WORKING DRAFT OF NEC CODE-MAKING
PANEL 13 MEETING OUTPUT

Document: National Electrical Code®

Revision Cycle: A2025

Panel Activity: Comment Stage

**Figure Informational Note
700.32 Emergency System Selective
Coordination.**

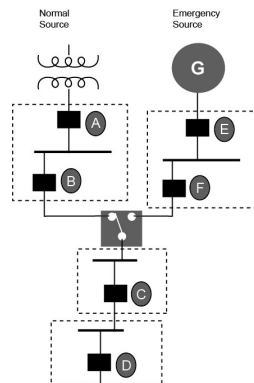
Informational Note 2: See Figure Informational Note 700.32 for an example of how emergency system OCPDs selectively coordinate with all supply-side OCPDs.

OCPD F selectively coordinates with OCPD E.

OCPD B is not required to selectively coordinate with OCPD A because OCPD B is not an emergency system OCPD.

Committee Statement: This was an editorial change made to have the informational note in the correct location and to correlate with section 701.32. The revision clarifies that if an OCPD is replaced with the same manufacturer, type, ratings and settings, then selective coordination would not have to be reevaluated. Overcurrent devices is corrected to OCPD to correlate with terminology throughout the code. This is in reference to Global PC 1653.

Figure Informational Note 708.54 Critical Operations Power System Selective Coordination.

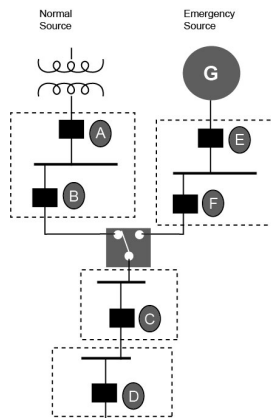
OCPD F selectively coordinates with OCPD E.

OCPD B is not required to selectively coordinate with OCPD A because OCPD B is not a critical operations power system OCPD.
